Docket Number:	17-AAER-06
Project Title:	Commercial and Industrial Fans & Blowers
TN #:	224825
Document Title:	Greenheck Comments on CEC Draft Staff Report on Fans & Blowers; June 2018; Publication Number CEC-400-2018-014-D
Description:	N/A
Filer:	System
Organization:	Greenheck/Michael L Wolf
Submitter Role:	Public
Submission Date:	9/28/2018 3:15:40 PM
Docketed Date:	9/28/2018

**Greenheck Comments on CEC Draft Staff Report on Fans & Blowers;
June 2018; Publication Number CEC-400-2018-014-D**

*California Energy Commission Staff
Workshop – Commercial and Industrial Fans
and Blowers, Docket 17-AAER-06*

Lower AHU power consumption yields lower FEI

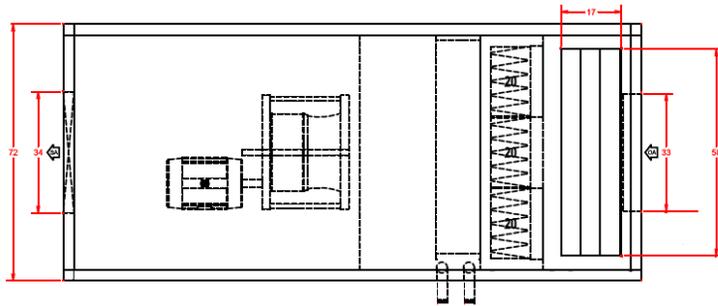
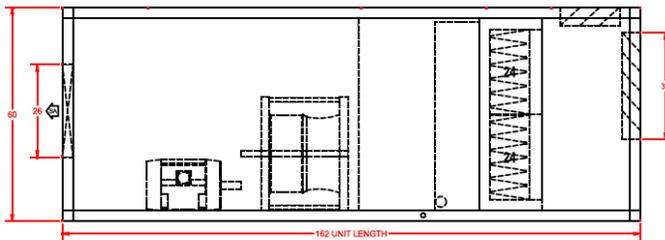
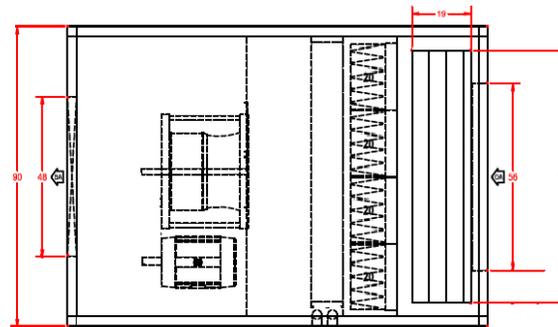
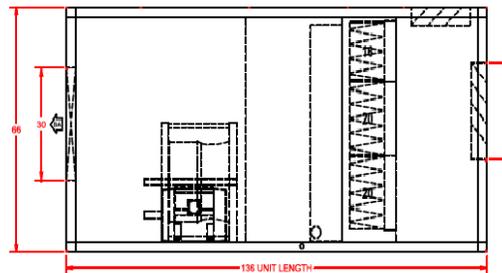
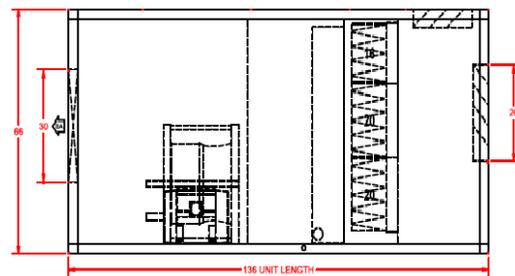
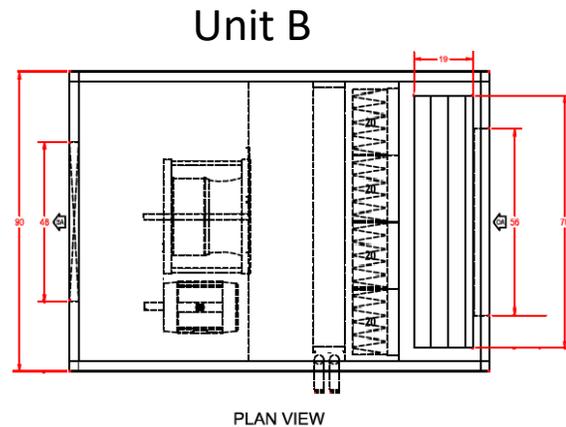
Other energy savings measures reduce FEI

- Only #1 yields improved FEI.
- Add a variable speed drive (#2), and wire-to-air efficiency drops, yielding a lower FEI.
- Reducing pressure drop for a given fan system usually reduces FEI. See the illustration at right and on the next page.

Each arrow represents a change in system design where the airflow and fan remain the same, but flow resistance is reduced.

- Only when the original fan selection is to the left of the peak, which is rare, does FEI go up.
- For the vast majority of selections, it goes down.

Two air handlers, with identical fans, motors and transmissions

The difference: Unit B has:

- A larger cabinet
- Larger coil and filter face areas
- Larger entrance and exit openings

A Variable Speed Drive is more efficient?

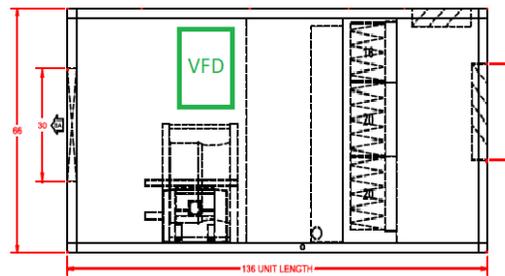
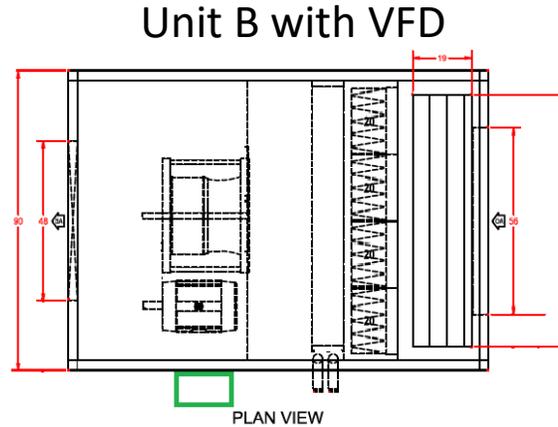
Adding a variable speed drive to a system, along with actually varying the airflow in operation is one of the best ways to save fan energy.

The units shown here are Unit B from the previous slide and the identical unit with a VFD.

- Clearly, there is no intention that the code discourage the design of more efficient systems. Here are some options to consider:
- For fans sold with variable speed drive, allow a lower FEI as long as the fan system will truly be operated as variable flow.
 - Proposed language:
 - (3) Commercial and Industrial Fans and Blowers. The FEI of commercial and industrial fans and blowers manufactured on or after January 1, 2020, shall be at least 1.0 or higher. If the fan system is to be operated as a variable flow system meeting the requirements of Title 24 Section 140.4.c.2.b and c then the FEI shall be 0.95 or higher.
- The difference in fan pressure rise is tougher to tackle. It must be made clear to consumers that a higher FEI does not necessarily result in energy savings when two fans not operating at the same duty point are compared.
